Mayals Road, Cycle Provision.

Stage 3. Road Safety Audit

Completion of Construction- Report Ref No. 00255.

Document Title	<i>Mayals Road, Active Travel 2021-2022, Cycle Provision Stage 3 Road Safety Audit</i>
Author	<i>L.H.Jones and M.J.Pinske</i>
Reference Number	<i>000255</i>
Owner	<i>Swansea Council</i>
Revision	<i>Revision A.</i>
Document Status	<i>Final</i>
Control Date	<i>11 July 2022</i>

Controlled Pedestrian Crossing – Clyne Drive.

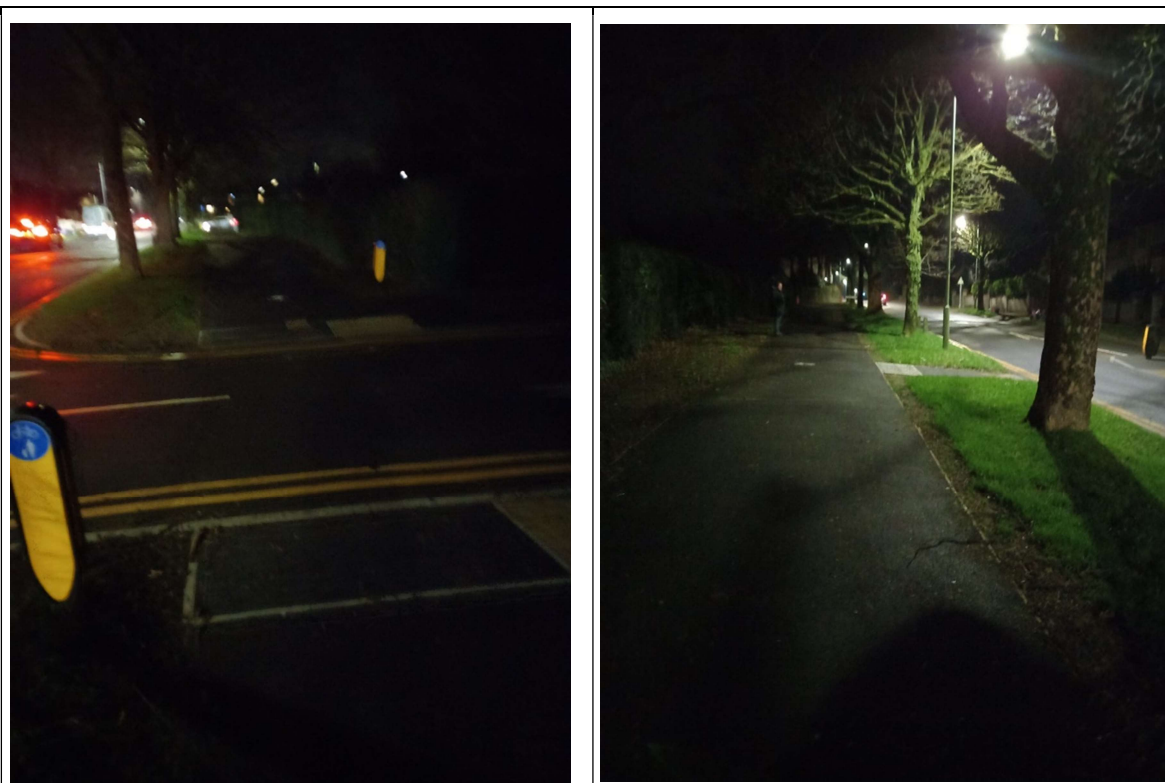
It was observed at night that pedestrians crossing from the south side to the north side of Mayals Road, using the controlled crossing, are not readily observed until they step well onto the crossing because that side of the street is not directly illuminated and the push button control is in darkness. This could result in pedestrians being struck by vehicles going ahead, especially if the push button isn't activated properly prior to crossing. This creates the potential for serious injury occurring.

Similarly, the signal control cabinet is in darkness and poorly orientated to open onto the footway during maintenance with the potential to block it almost completely. This in turn creates a hazard for pedestrians.

It is recommended that the area around this side of the crossing be properly illuminated. Also, that the orientation of the control cabinet be amended to provide a separate service area, not compromising the footway during Telematics maintenance.

Designers Response – *Within Traffic Signs Manual: Chapter 6: Traffic Signals (2019) reference is made to supplementary lighting to allow pedestrians waiting to cross to be adequately seen by drivers, however this is not a specific design requirement. During the design process, detailed advice on suitable lighting level was sought from the Council’s public lighting section. Under design guidance “TR12 – Lighting of pedestrian Crossings” Pedestrian Crossings with traffic lights are not required to be lit to a higher standard.*

Under normal fault free operation when the pedestrian demand button is pressed the crossing facility will immediately provide pedestrians with a green signal to cross, following the completion of all relevant all red safety times. This operation means pedestrian delay is kept to an absolute minimum and almost completely removes any situation of a pedestrian waiting to cross the carriageway irrespective of the lighting levels at the time. The only times when the facility would differ from this operation are: Namely, if a pedestrian has already operated the crossing and a second pedestrian demand is inputted immediately after the green man signal phase has ended. In this instance, the signal timings have to cycle through their minimum phases until the next pedestrian phase can be called, this has a maximum limit of 30 seconds before the second pedestrian is given a signal to cross. The only other instance where a delay may be encountered, would be under fault conditions.

The design team will monitor the signal operation and report any findings in the Road Safety Audit Stage 4.
